SINGLE ENGINE AIRCRAFT SERVICE KIT NO. 150

SUBJECT: FLIGHT CONTROLS (ATA NO. 27) AILERON,
MODIFICATION OF

August 3, 1979

PURPOSE/DISCUSSION: The purpose of this service kit is to modify the aileron to prevent possible oscillation during flight.

FIGURE 1

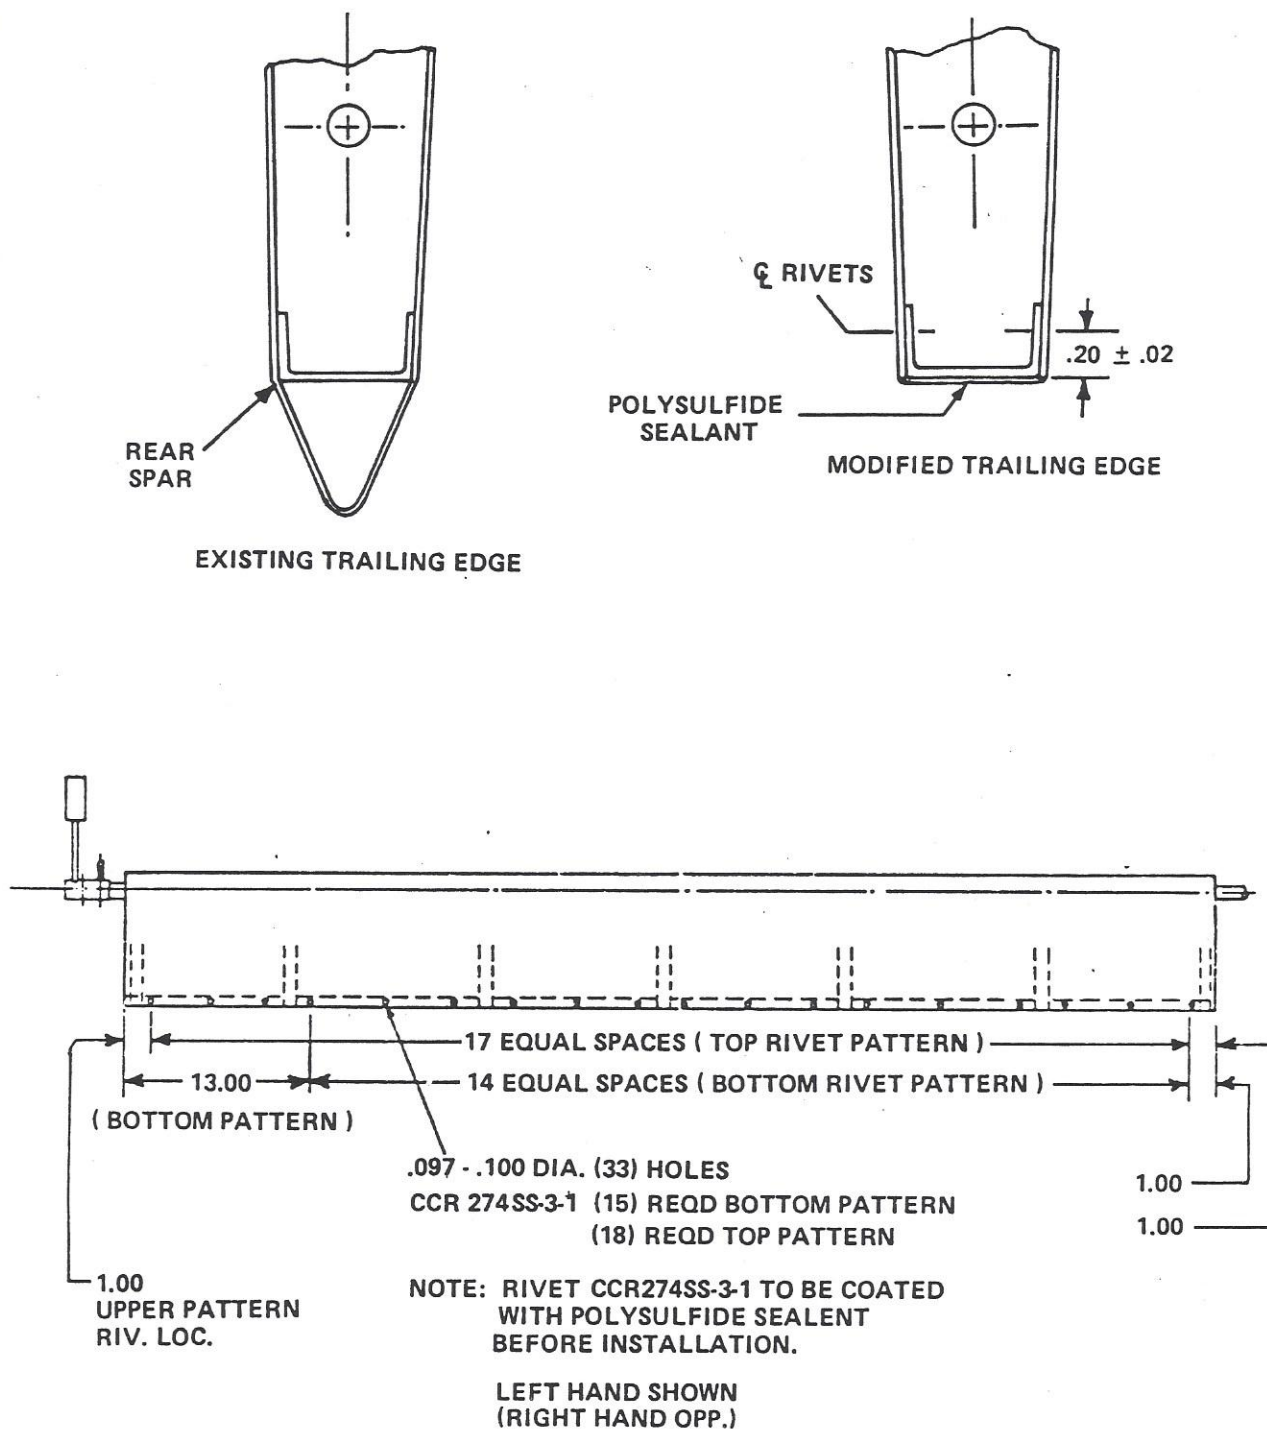
- A. Prepare the aircraft for safe ground maintenance as follows.
- A-1 Insure that the Master Switch is OFF and all aircraft System Switches are OFF.
 - A-2 Insure aircraft is grounded.
 - A-3 Comply with all safe maintenance practices as recommended in the Maintenance Manual and FAA Regulations.
- B. Rework Instructions
- B-1 Block the ailerons to prevent aileron movement.
 - B-2 Remove the aileron trim tab. Retain for reinstallation. Drill .097 - .100 dia holes in aileron rear spar in-board end and the top outboard end per Figure 1 and install CCR274SS-3-1 rivets. Installation of rivets is to prevent corners from spearating.
 - B-3 Remove aileron trailing edge skin flush with the rear spar on the left and right hand aileron. See Figure 1.

When cutting the trailing edge, make initial cut well away from the bond line and use care on final cut to prevent delamination to bond line. Leave .03 to .05 extention for final filing, to prevent damage to rear spar.

- B-4 Smooth skin edges flush with rear spar, using strokes toward center line or parallel to trailing edge. See Figure 1.

- B-5 Drill .097 - .100 dia holes in top and bottom of the aileron trailing edge as shown in Figure 1.

- B-6 Install CCR274SS-3-1 rivets in the trailing edge of the aileron as shown in Figure 1. Dip rivets in CS3204A2 Polysulfide sealant before installing.

(TYP) TRIM TAB INSTALLATION
AFTER ALTERATION
TAB INSTALLED
BOTTOM

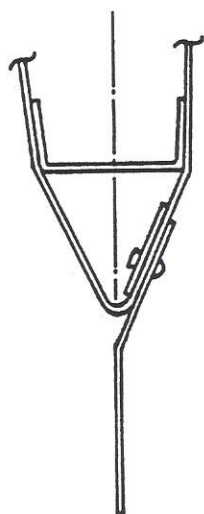
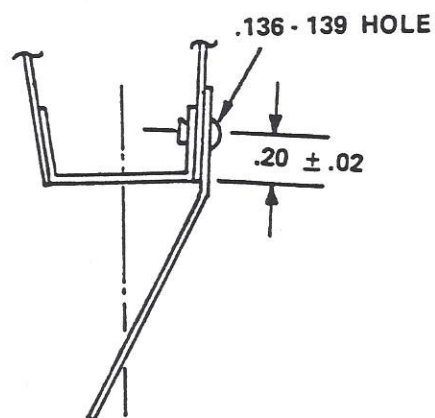
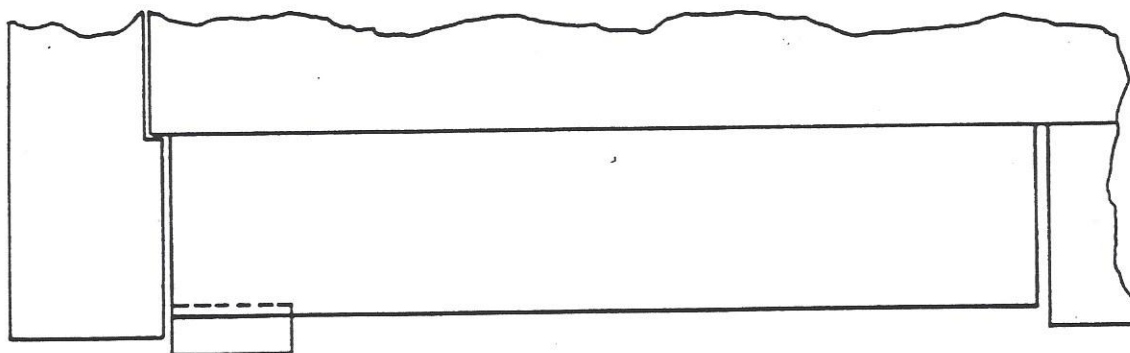
- B-9 Apply zinc chromate primer to repair area prior to repainting.
- B-10 Turn the aileron trim tab up side down and install on bottom surface as shown in Figure 2 using 1601-0410 rivets.

FIGURE 3

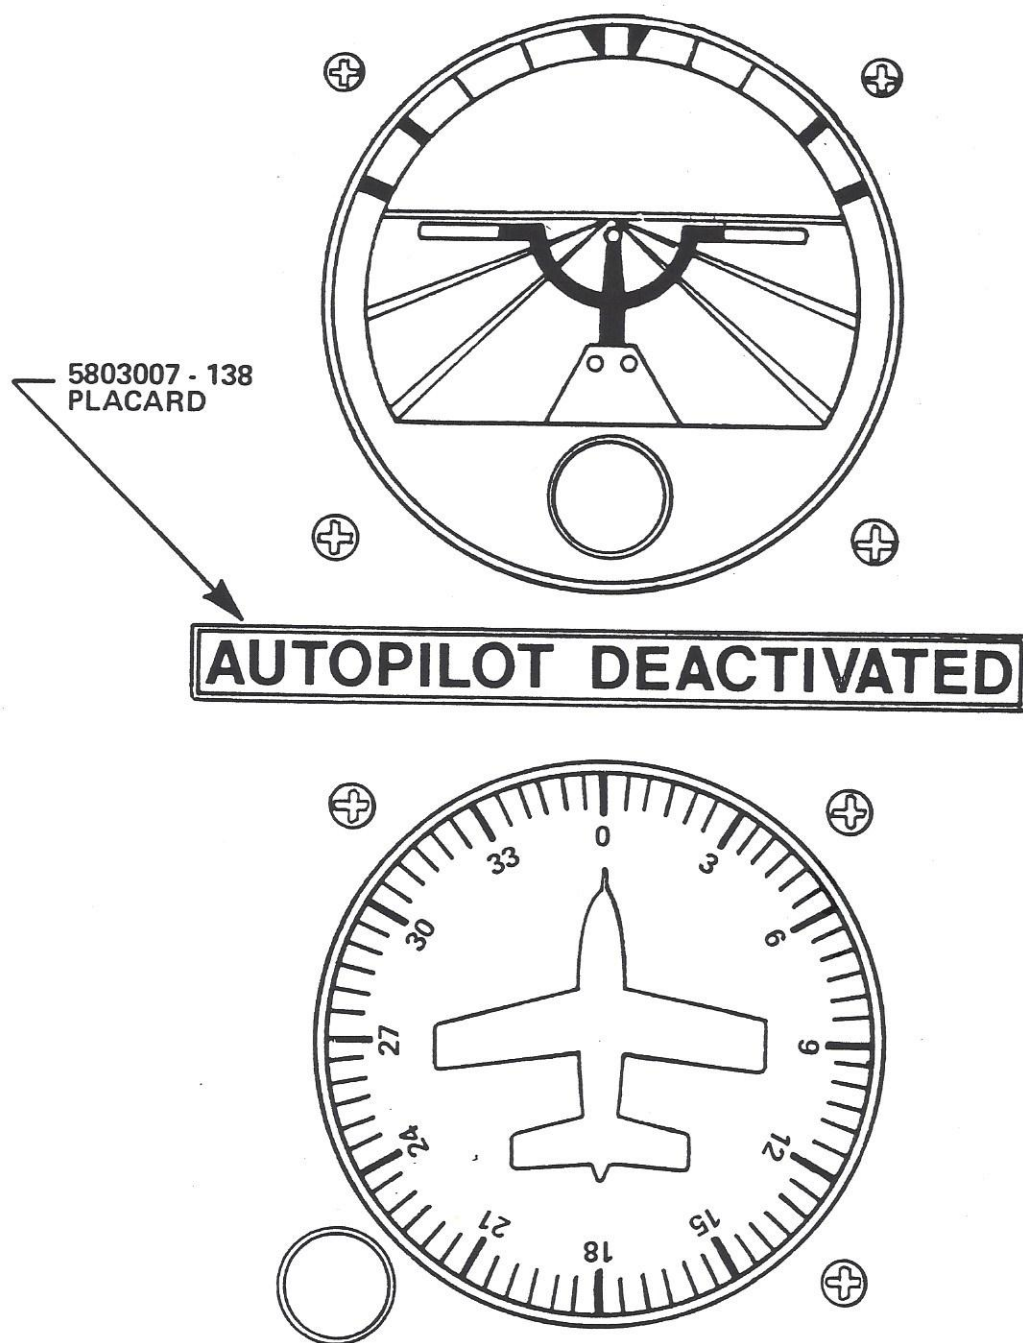
- B-14 Install "autopilot deactivated" placard as shown in Figure 3.
